NAVAL MEDICAL RESEARCH INSTITUTE
BETHESDA, MARYLAND

81 - 47
HUMAN ENGINEERING EVALUATION
OF THE
HYPERBARIC RESEARCH FACILITY
(PHASE 1)

J.I. Brady and M.D. Curley

Fig. 2. Diver of fifth percentile height having difficulty reaching chamber closure button.

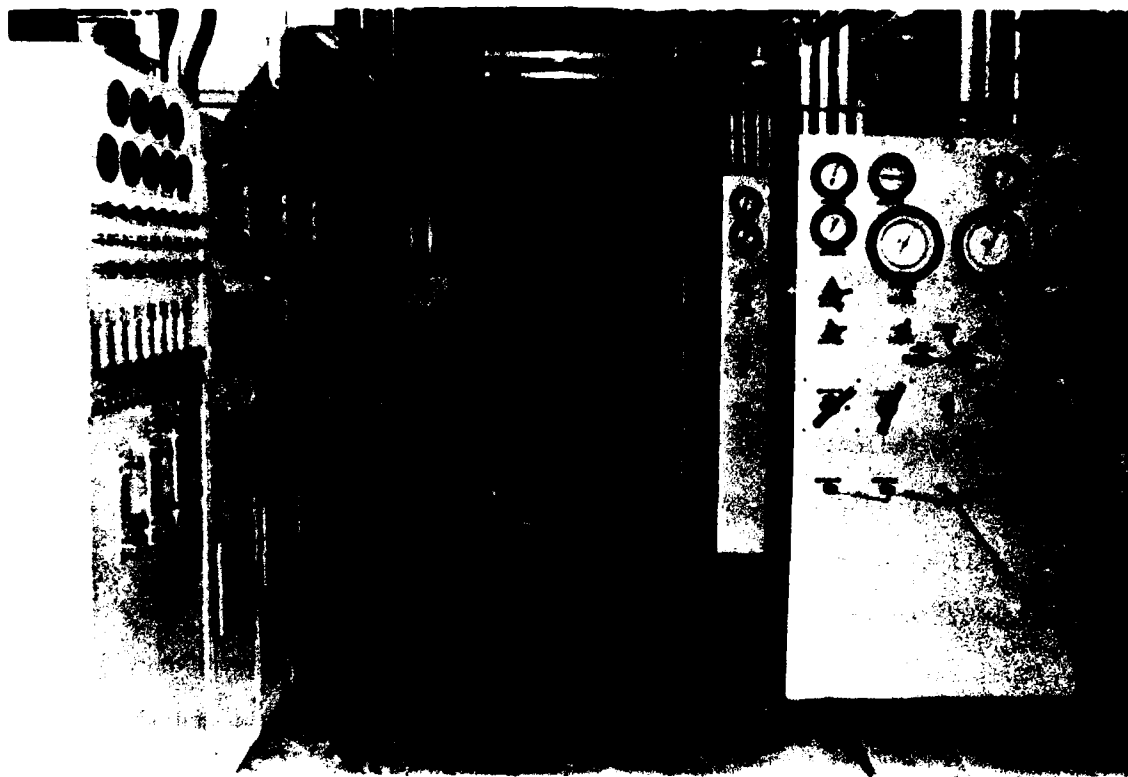
- (4) Even when standing, certain operators will have difficulties reaching all necessary control devices (Fig. 2). Consequently, it is recommended that a 4-in. high padded deck be added to the existing concrete surface directly in front of the master control consoles. This deck should not extend out to the local control panels or the gas analysis panel; however, these areas should be provided with a durable padded surface of no more than 1-in. in height. (Priority 2)

Fig. 4. Diver indicating 3-4 in. gap between deck and chamber.

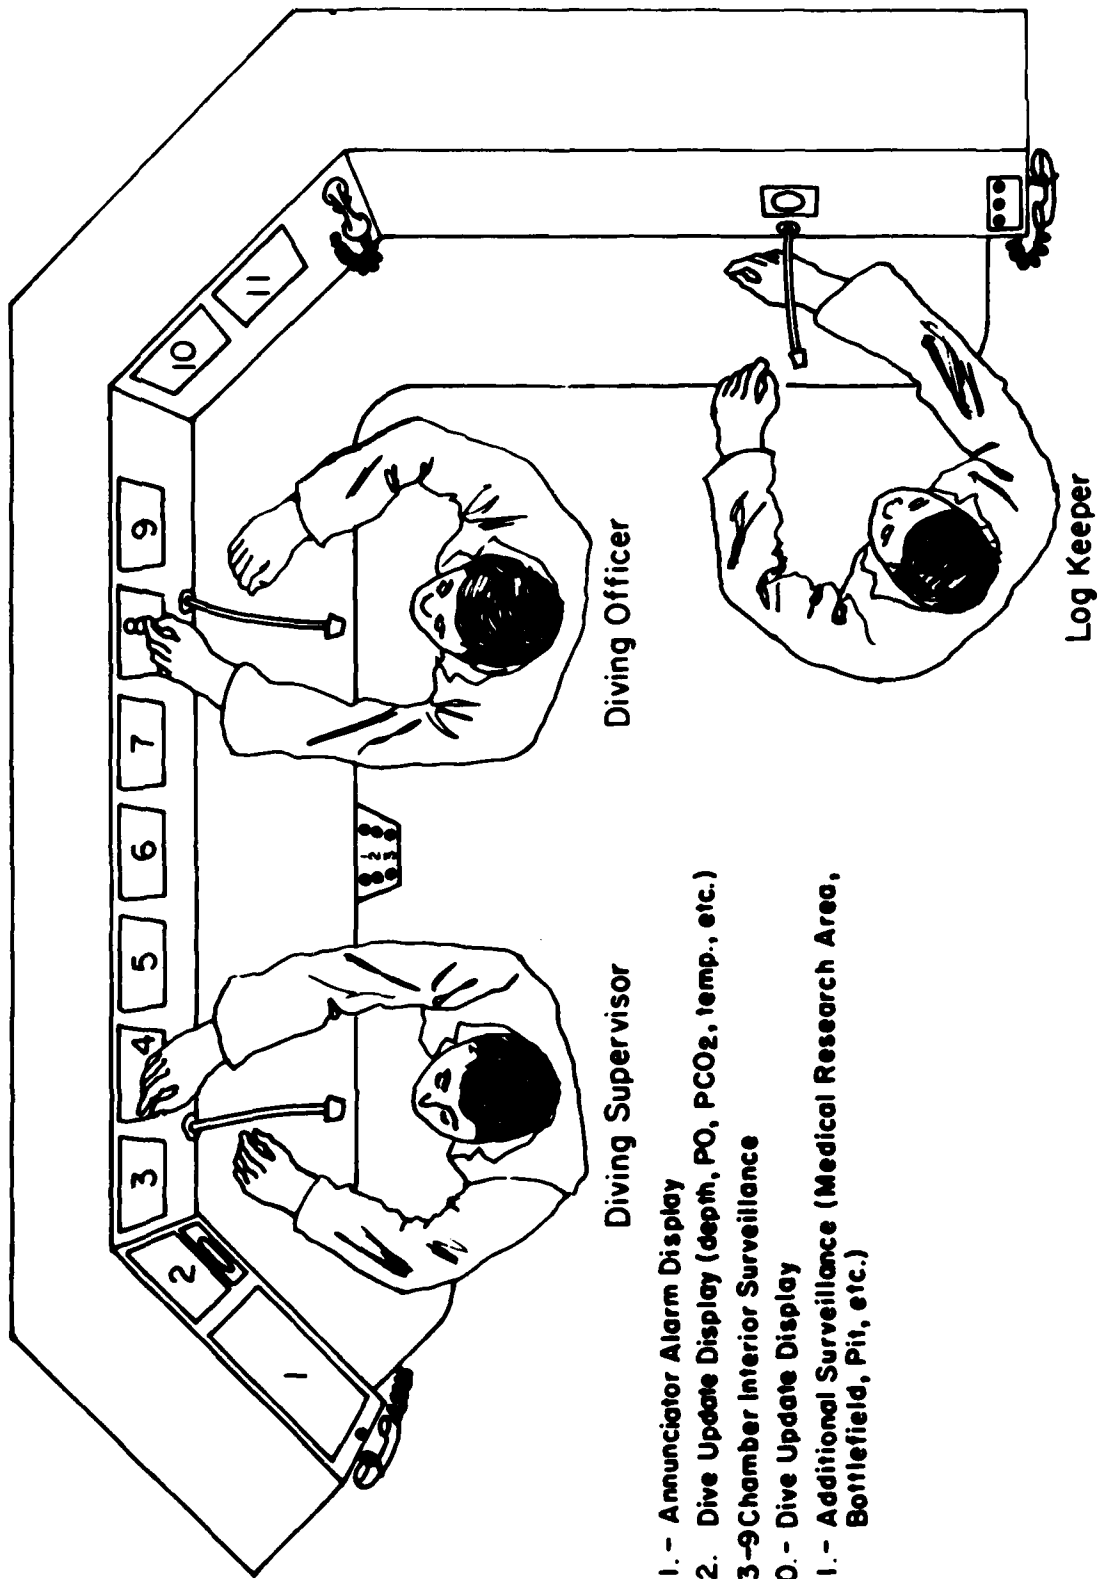
(6) Currently a gap exists between the metal deck in the control area and the side of the chamber (Fig. 4). Since tools or objects could accidentally be dropped into the pit below injuring someone or damaging equipment, it is recommended that this gap be closed off in some manner. (Priority 2)

Fig. 5. Possible layout for a central monitoring console to accommodate the diving officer, diving supervisor, and log keeper.

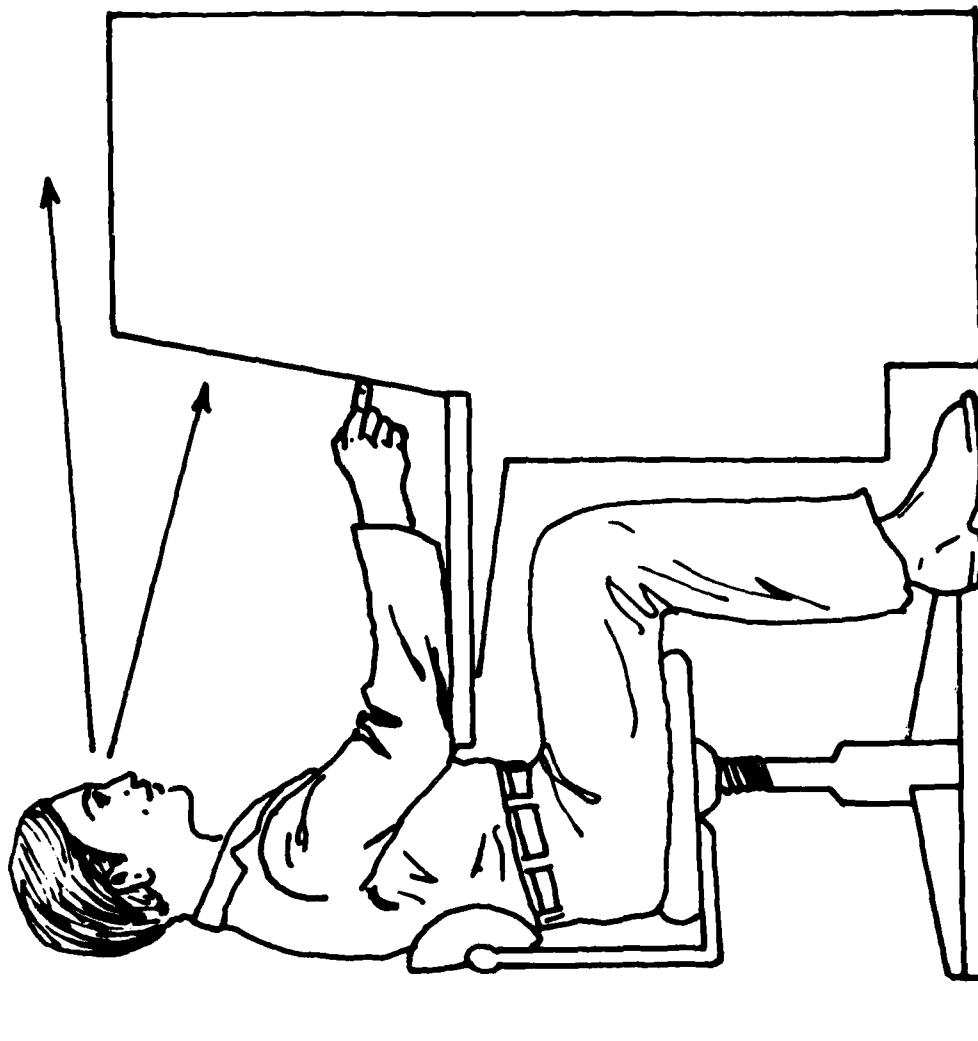
(7) The present console design does not provide an adequate diving officer and diving supervisor watch station. Such a watch station should function primarily as a central monitoring location. Figures 5 and 6 show a recommended layout for this watch station. Figure 7 indicates the suggested location for the station. This location provides a complete view of the master control consoles, as well as easy access to the medical research area and visitor observation areas. (Priority 2)

Fig. 7. Recommended location of central monitoring console.

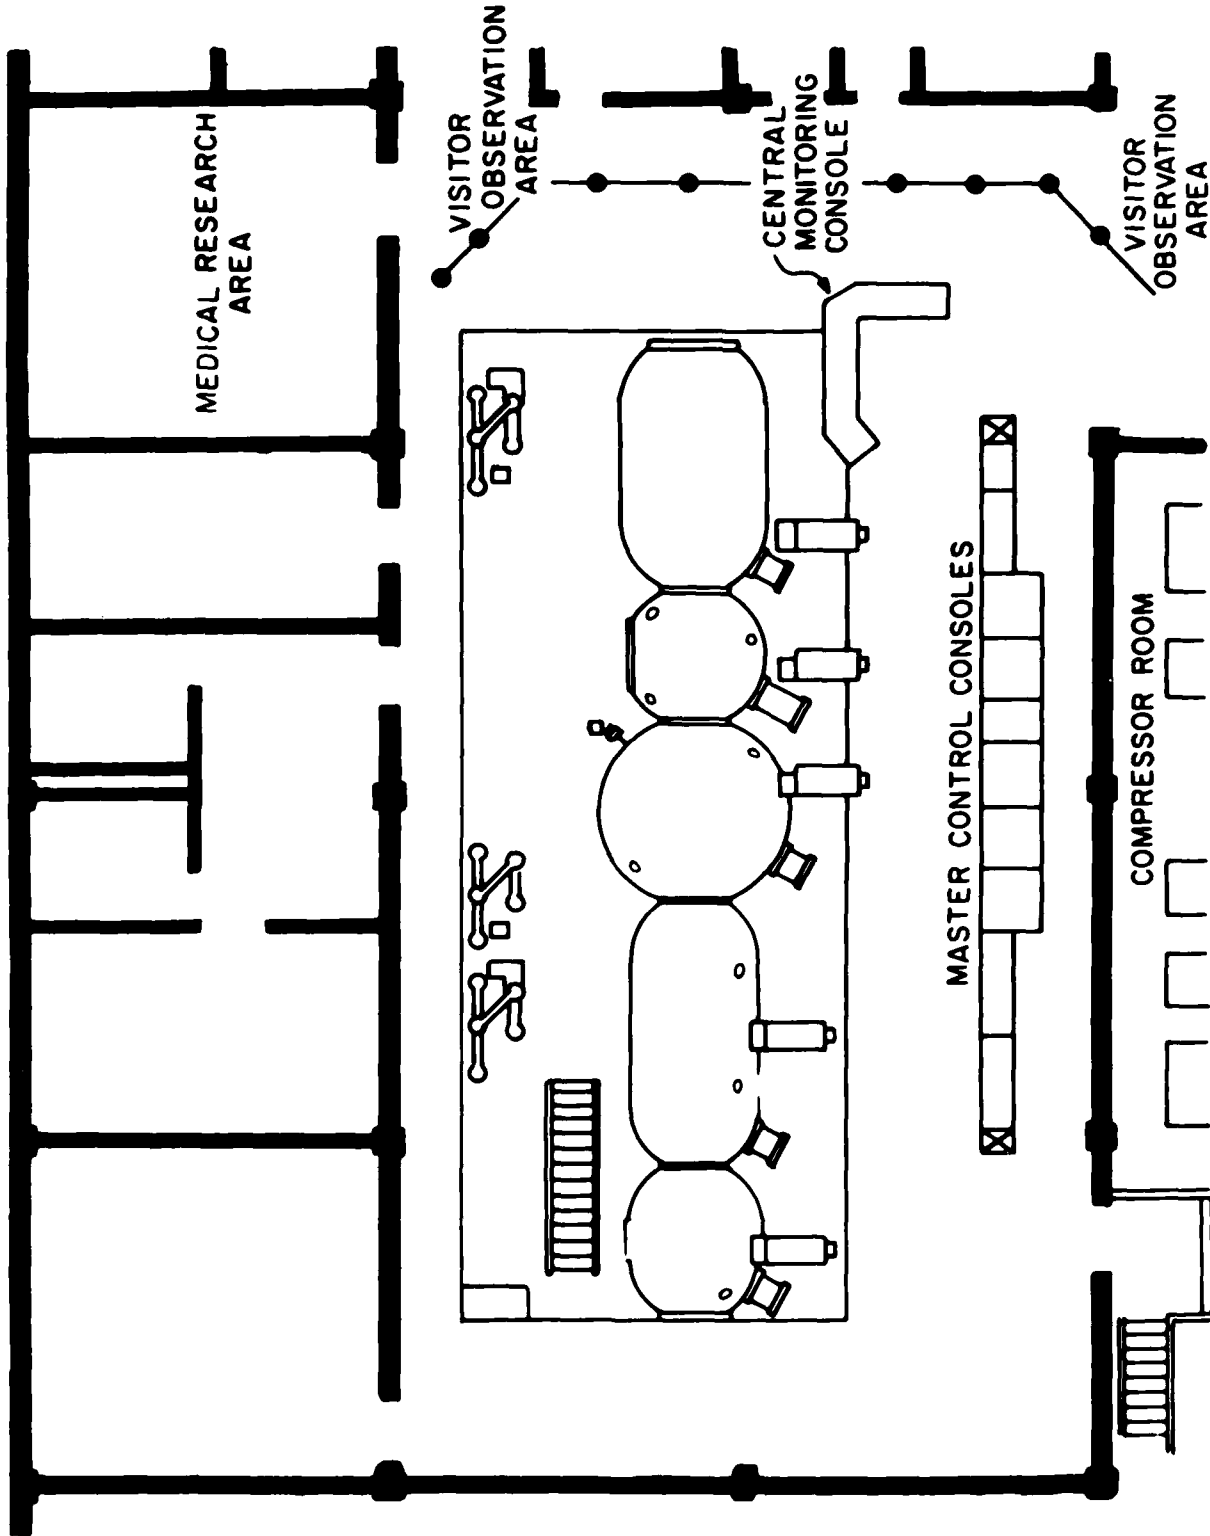
Until now, a location for the biomedical research equipment and research personnel during diving operations was not allocated. The recommended site for such a capability was shown previously in Fig. 7. (Priority 1)

Fig. 14. Fifth percentile diver having difficulty reading bottlefield bank pressure gauge.

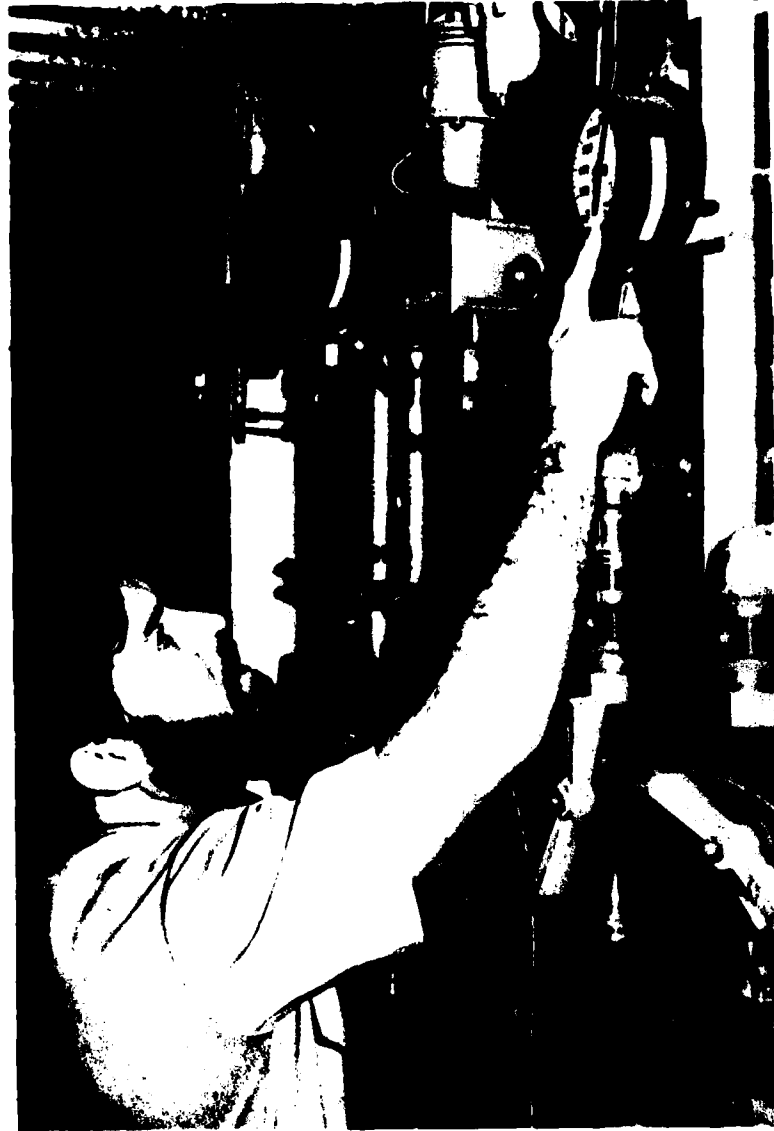
- (26) Bank pressure gauges in the bottlefield should be repositioned or at least tilted down for more efficient viewing (Fig. 14). (Priority 4)
- (27) A slightly elevated walkway (1-2 in.) through the bottlefield alleyway will provide better footing, easier access to some difficult to reach valves, and greater readability of the bank gauges (Fig. 15). However, it should not be so high as to cause head clearance problems with lights, etc. (Priority 4)

Fig. 16. Bottlefield oxygen regulators and valving are located outside and have no protection from inclement weather.

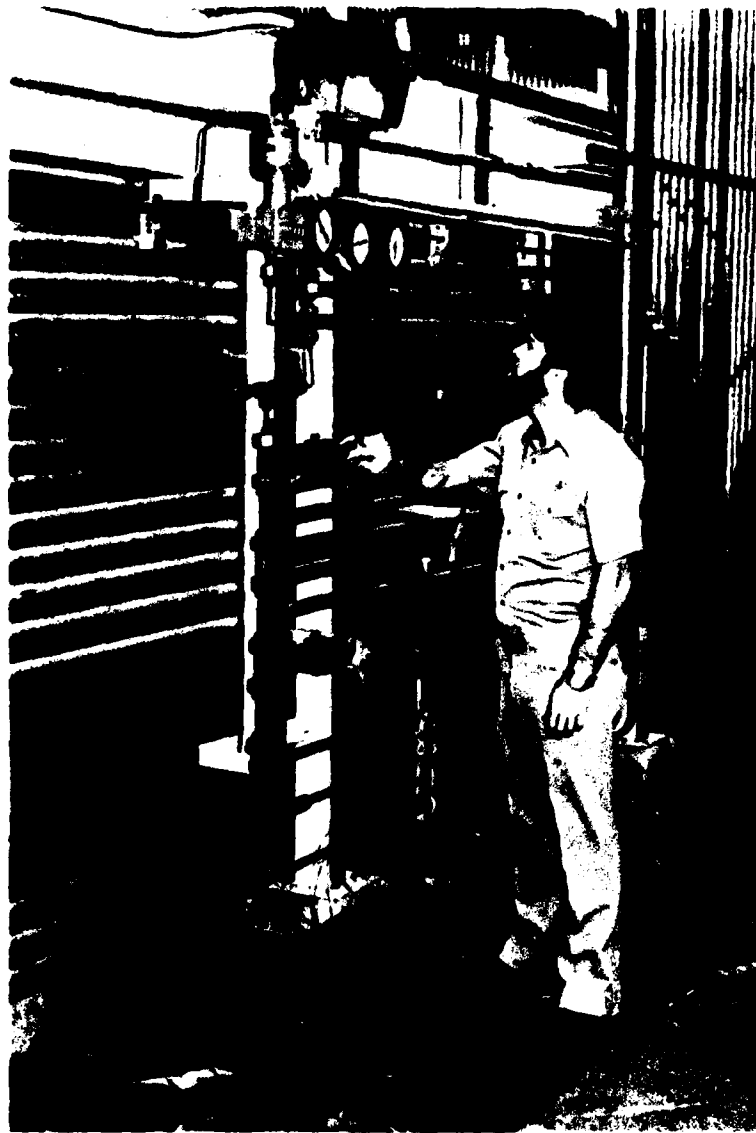
- (28) A protective roof or hood to shield the bottlefield oxygen regulators and their associated valves from ice and snow in the winter is recommended (Fig. 16). (Priority 2)

Fig. 20. Hatch opened in D chamber and obscuring the fold-down sink.

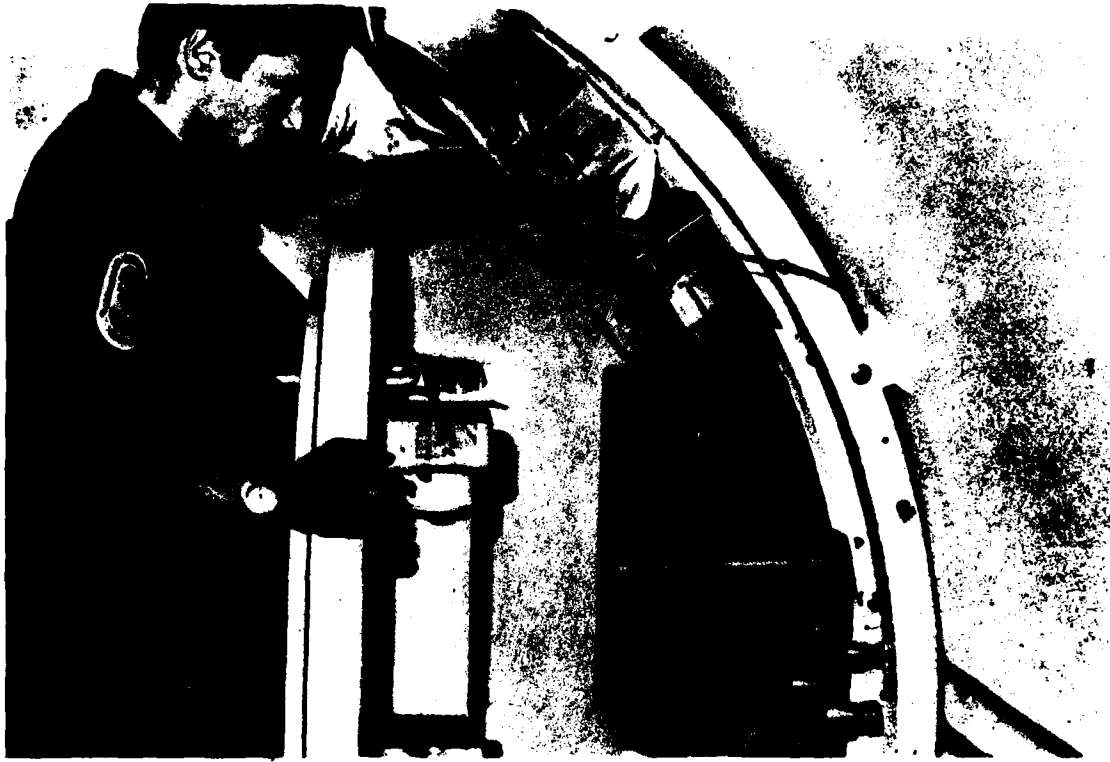
- (33) If the entire chamber complex is taken to depth (during a saturation dive for example), the open hatch door between E chamber and D chamber will prevent access to the sink (Fig. 20). Unless the sink is relocated or unless E chamber is left unpressurized, divers will have to partially close the rather cumbersome hatch each time they wish to use the sink. (Priority 2)

Fig. 23. Removable brackets for bunks in C chamber.

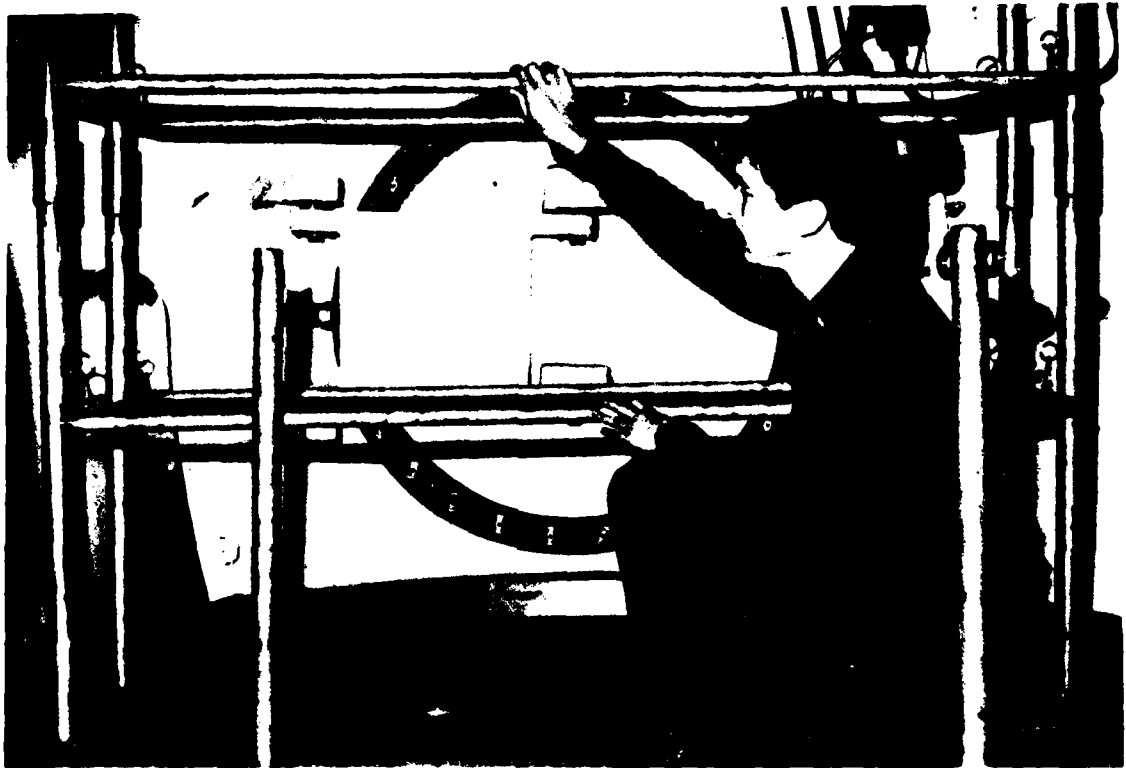
- (38) The removable bunks in C chamber (Fig. 23) should be moved to permanent locations in other chambers. See Fig. 24 for recommended locations. (Priority 2)
